SUBMISSIONS AND AMENDMENT REPORT

NEXTDC S4 Data Centre, Horsley Park
(SSD-63741210)

Figure 2 Comparison Between Original and Amended Site Layout

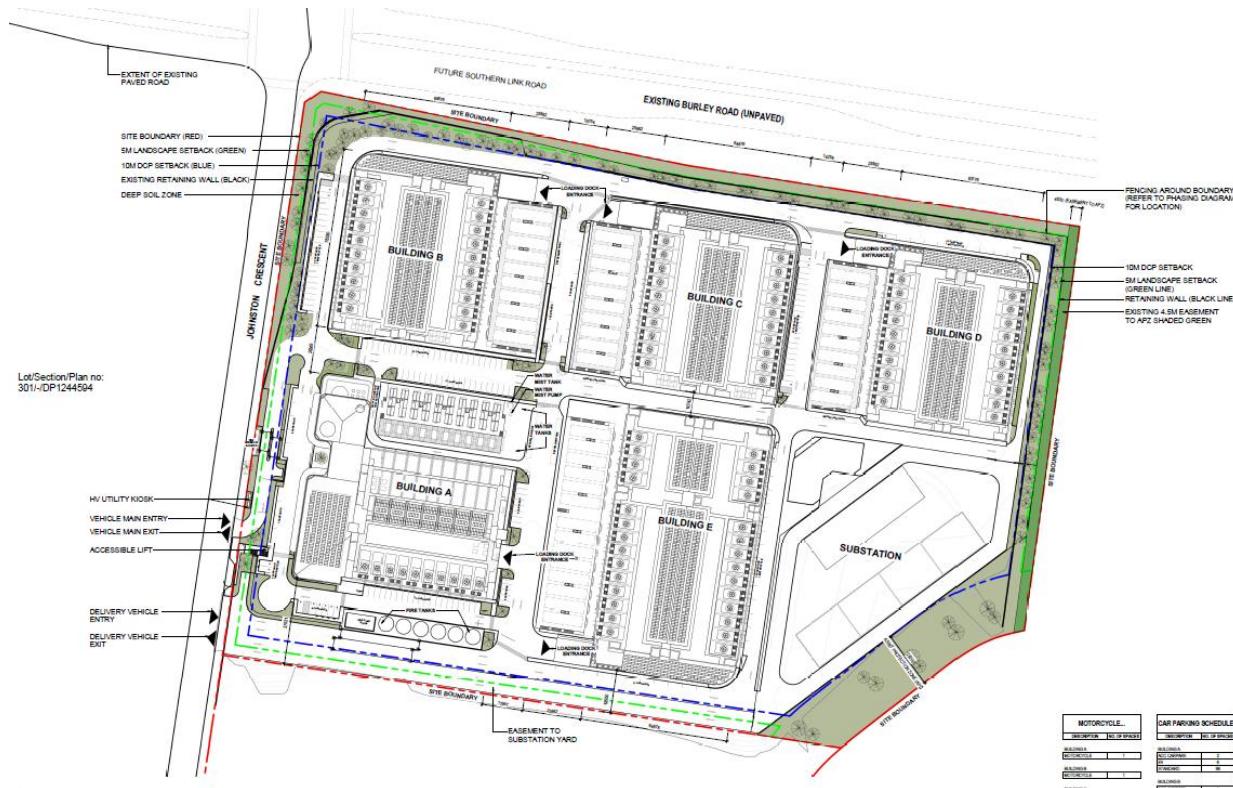
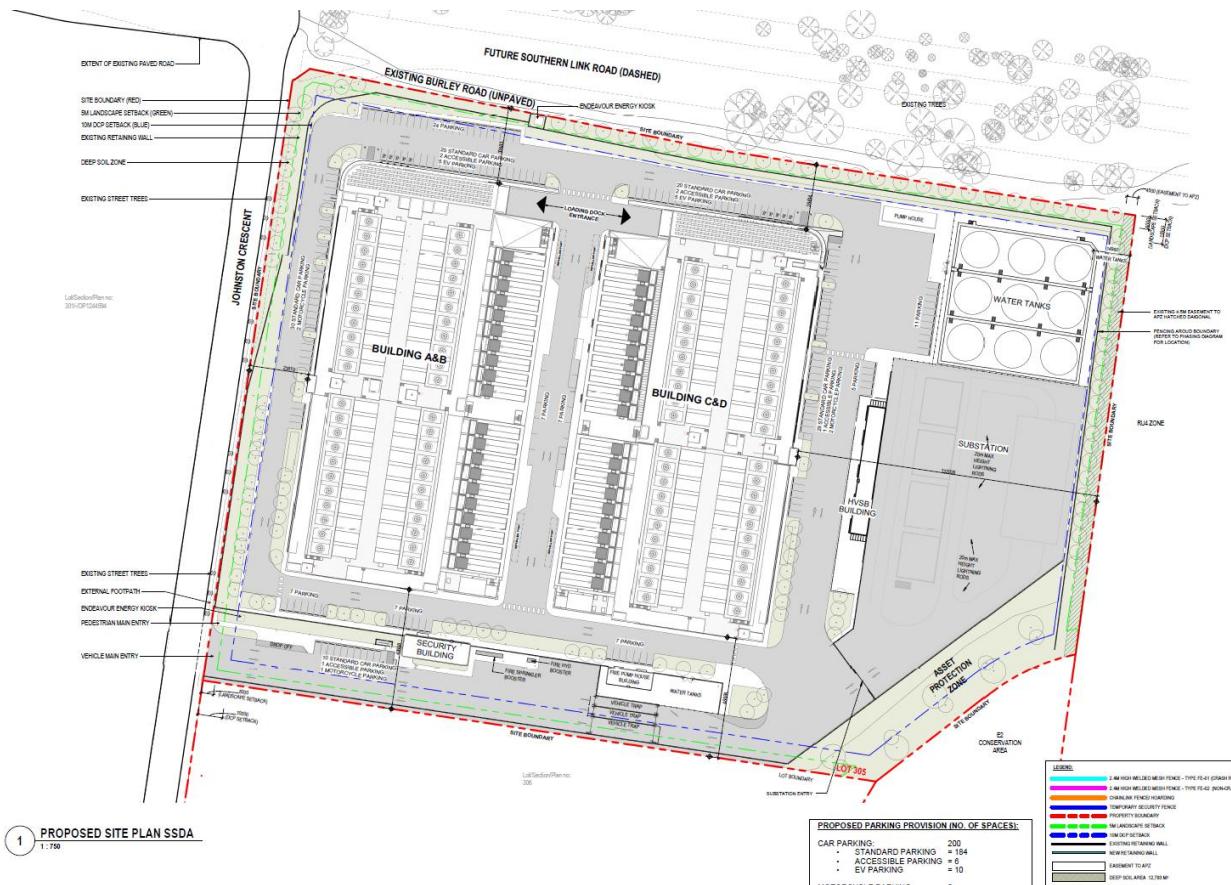
The site entry and internal circulation have been revised, with the main vehicle entry relocated to the southern internal road to support more efficient traffic flow. A new Security Operations Centre (**SOC**) is located at the entrance to improve access control and site security. Car parking and internal roads have been reconfigured in response to the revised building layout.

Substation infrastructure has been repositioned to align with the proposed high-voltage cable route, and ancillary plant areas have been consolidated to improve operational efficiency. A new pump house is also proposed along the north-eastern boundary.

A comparison between the original and proposed site layout is provided at **Figure 2**. Overall, the amended layout results in a more integrated and functional site arrangement, with improved boundary treatments, landscape outcomes, and consistency with the surrounding context.

The revised design achieves a more efficient and integrated built form. By combining Buildings A and B into Building AB, and Buildings C and E into Building CD, the proposal simplifies the site layout, reduces structural duplication, and enhances operational efficiency. These changes support improved internal circulation, coordinated infrastructure servicing, and more flexible construction staging.

Figure 7 Revised Landscape Master Plan

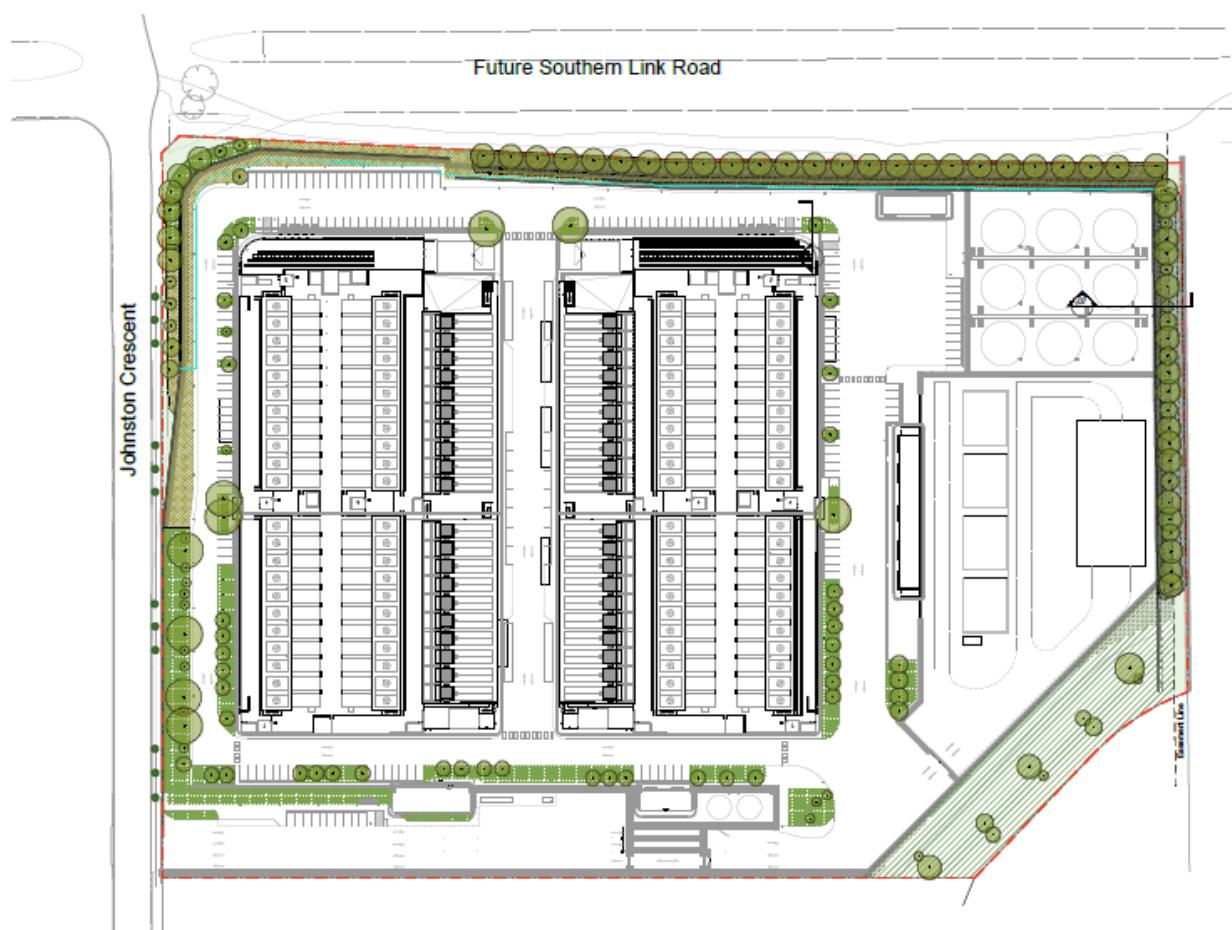
The amended proposal includes an updated landscaping plan that responds to the revised site layout and improves how the development sits within its surroundings, including nearby residential rural and environmental conservation zones.

By removing Building D and reducing the overall building footprint, the proposal allows for wider setbacks and an increase in deep soil planting, especially along the eastern boundary. This creates a stronger landscape buffer between the data centre and adjoining R5 Large Lot Residential and C2 Environmental Conservation zoned land, helping to soften views and reduce visual impact.

Figure 15 Revised Parking and Access Arrangements

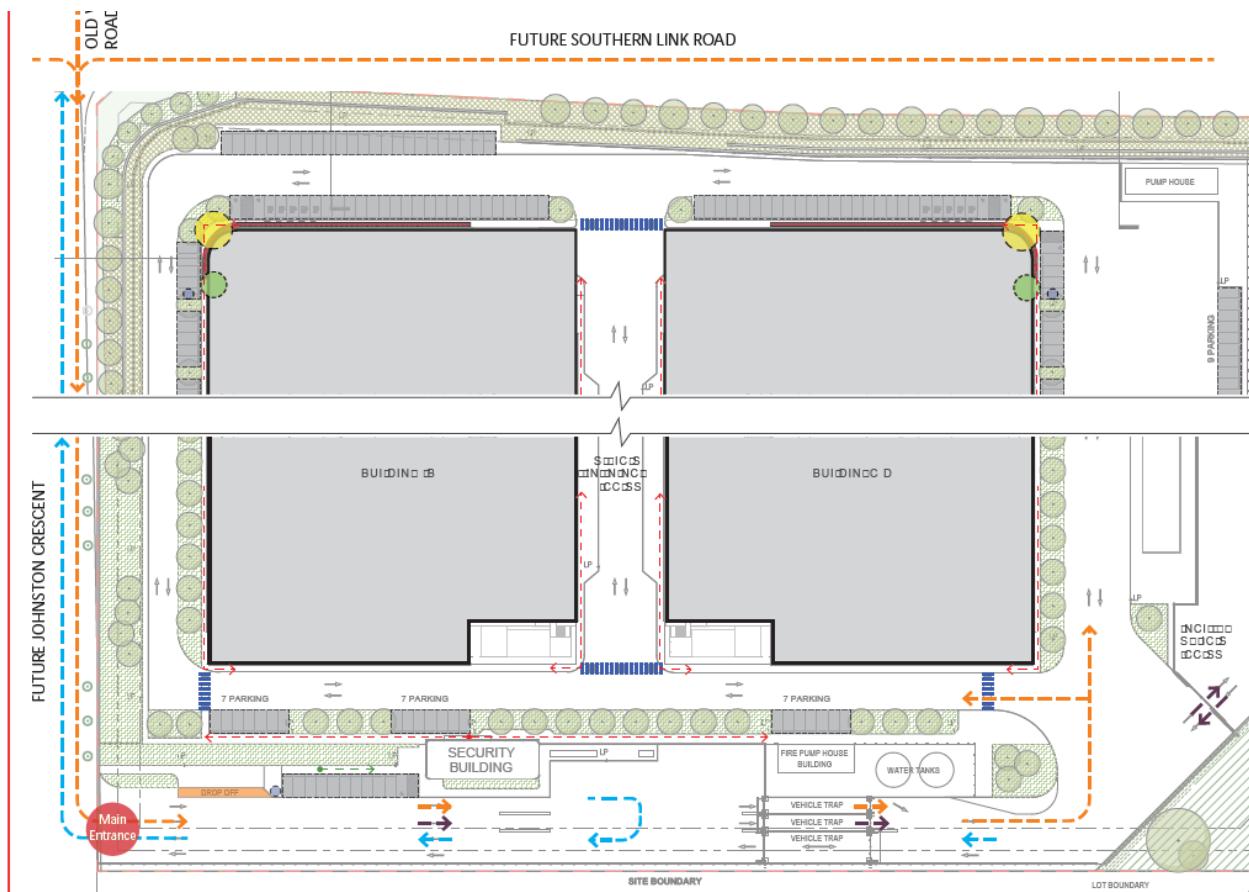
A total of 200 on-site parking spaces will be provided, consistent with the original proposal. These spaces have been relocated to a more centralised position within the site to better support operational needs and optimise internal circulation. The parking layout has been designed to safely accommodate staff, visitors, and service vehicles, with dedicated pedestrian paths and crossings linking parking areas to building entrances.

Figure 16 Revised Cut and Fill Plan

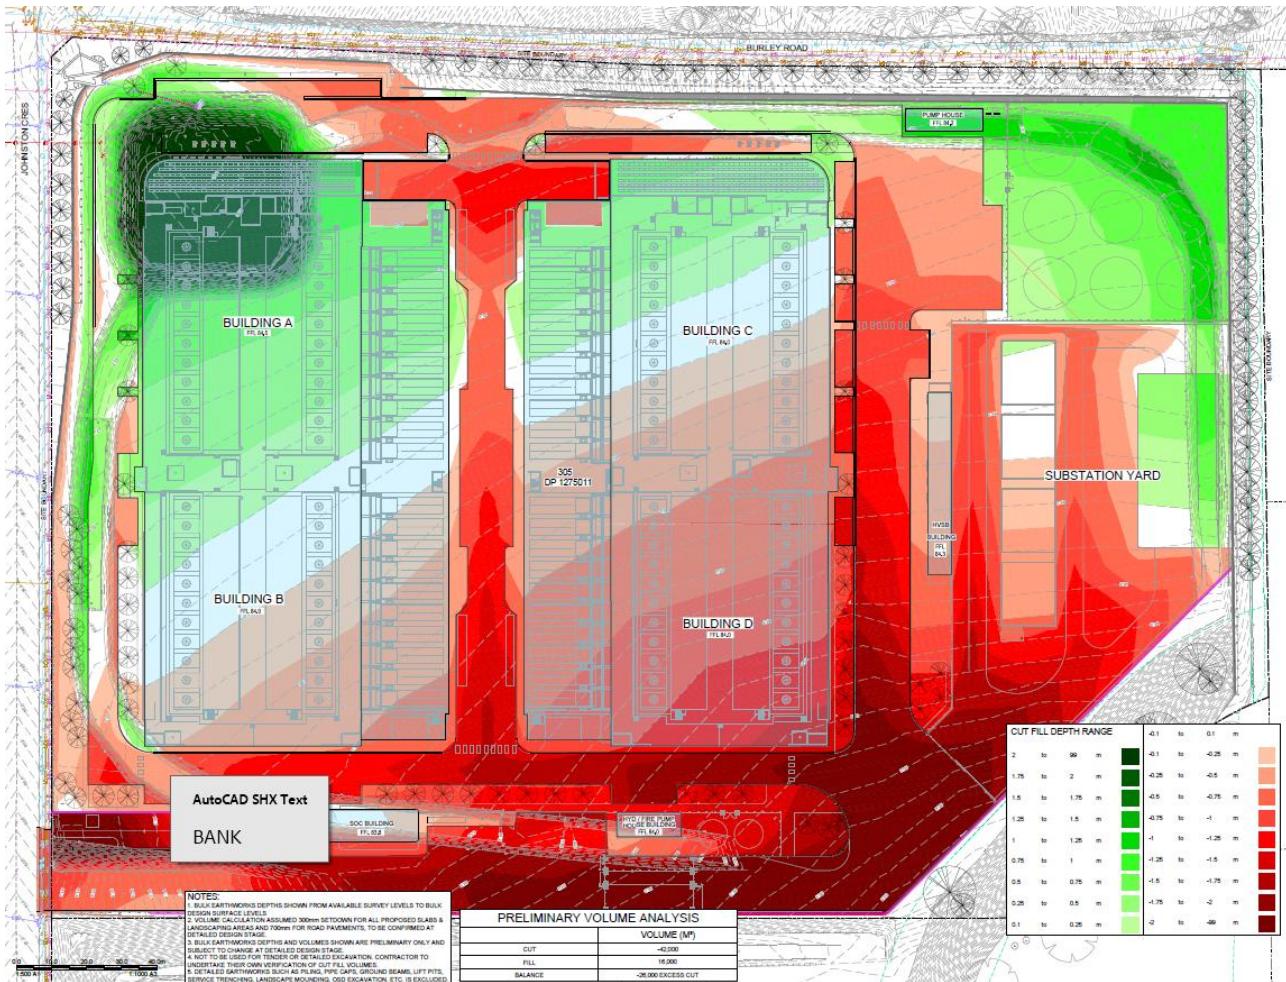
Site preparation works will include additional bulk earthworks to establish building pads with a total net cut (excavation) of approximately 26,000m³. As shown in **Figure 16** most of the cut is within the southern portion of the site, with a maximum cut level of between 1.75 metres to two metres.

Figure 17 Revised Staging Plan

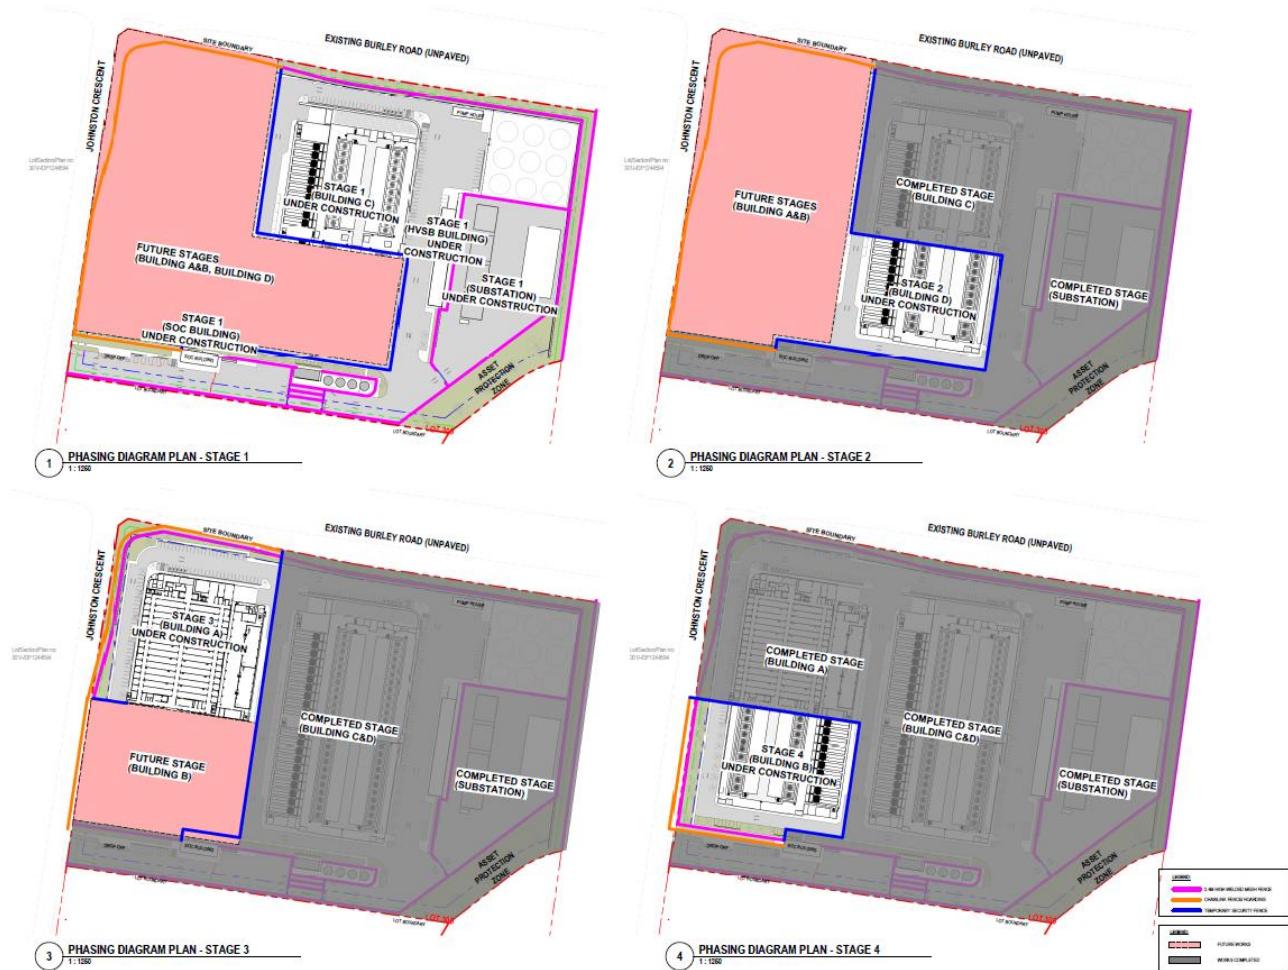
All construction works associated with the main data centre site are proposed to be in accordance with the original scheme and EIS.

Activities within the TransGrid Sydney West Substation will be undertaken primarily during standard construction hours. As the external HV cable route along Old Wallgrove Road involves road works, installation will require sequential lane closures and will primarily be undertaken at night (subject to approvals) to minimise traffic disruption.

Figure 18 North and South Elevations

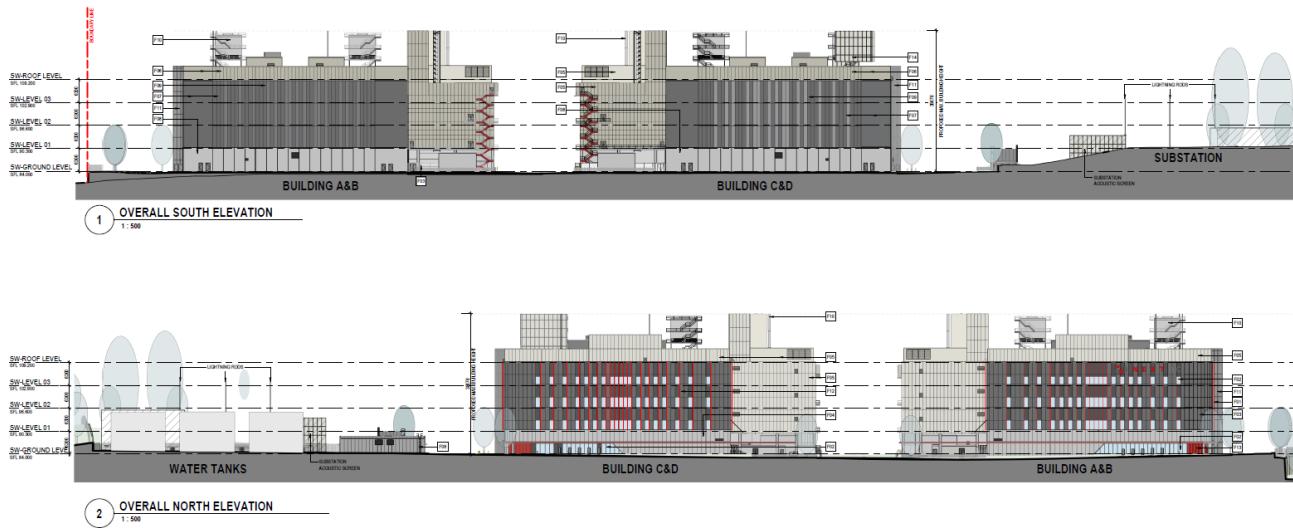
The revised height, combined with increased landscaping along sensitive boundaries (particularly the eastern edge), improves the overall interface with the adjoining rural residential area. The amended built form achieves a more refined and context-responsive outcome in terms of scale and visual impact, while maintaining the functional requirements of a large-scale data centre campus.

Figure 19 Shadow Diagrams

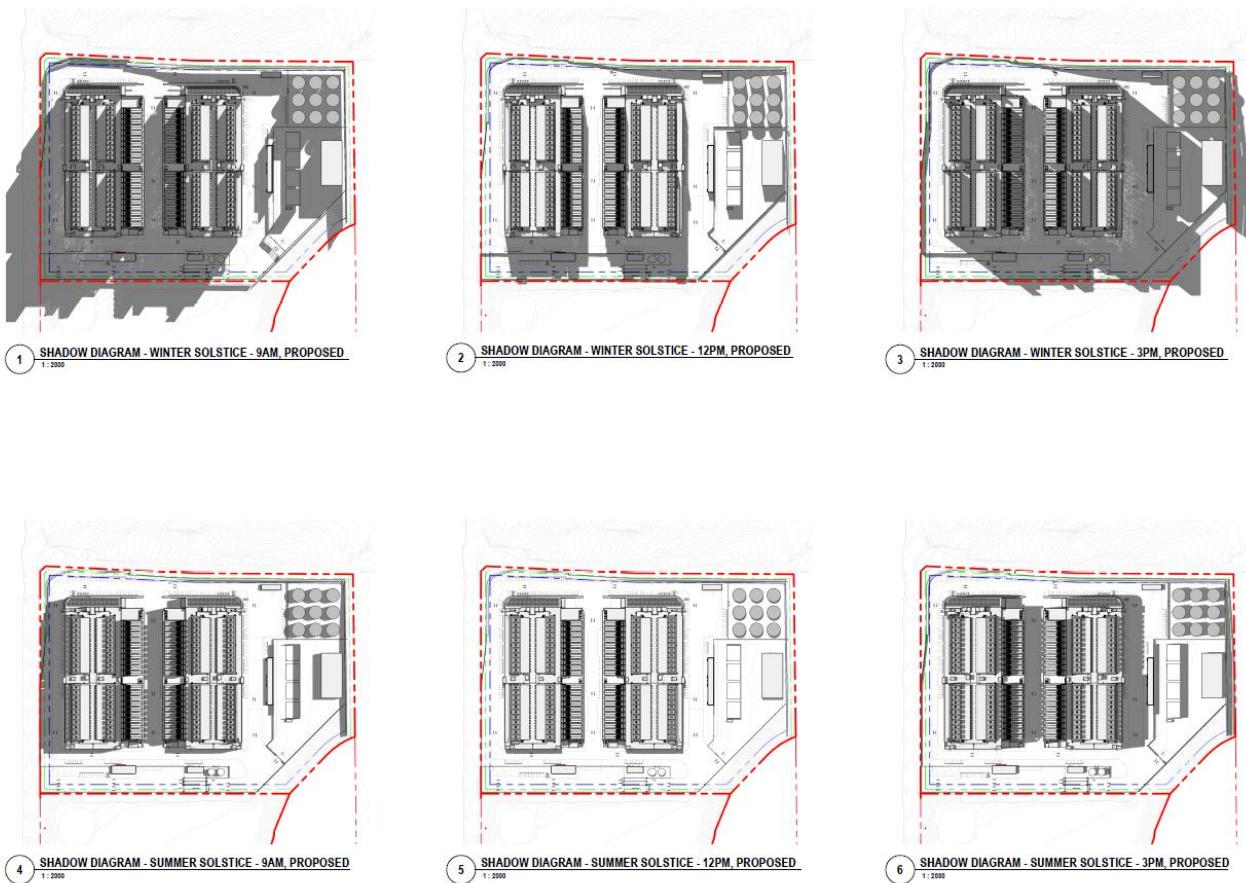
An updated overshadowing analysis, prepared by HDR (refer to **Figure 19**), confirms that the amended proposal will not result in any discernible shadow impacts on the adjoining RU4 zoned land to the east. While some overshadowing is expected to the south west during the winter solstice, it dissipates by 12pm. This area comprises existing roads and vacant industrial zoned land, and the overshadowing is considered acceptable given its limited duration and negligible impact between 10am and 2pm.

Figure 29 Revised Stormwater and Drainage Plan

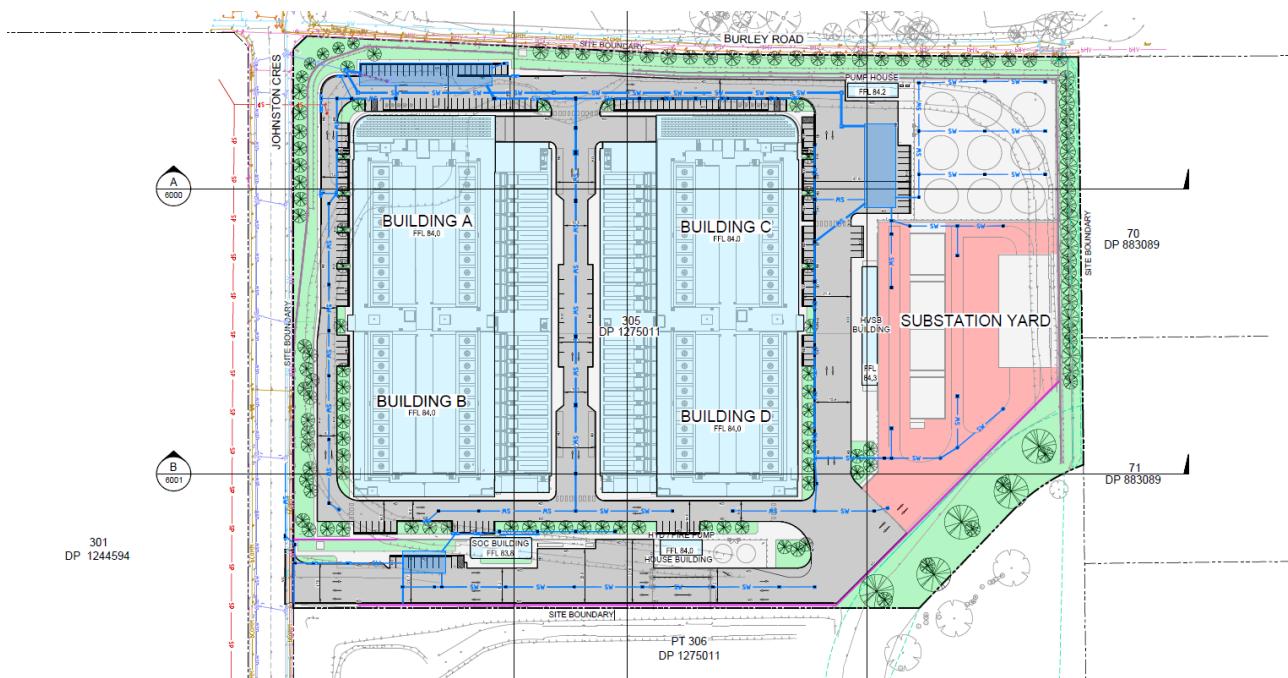
Minor design amendments have been introduced to respond to the changed building siting. The amended stormwater drainage design is shown in **Figure 29**.
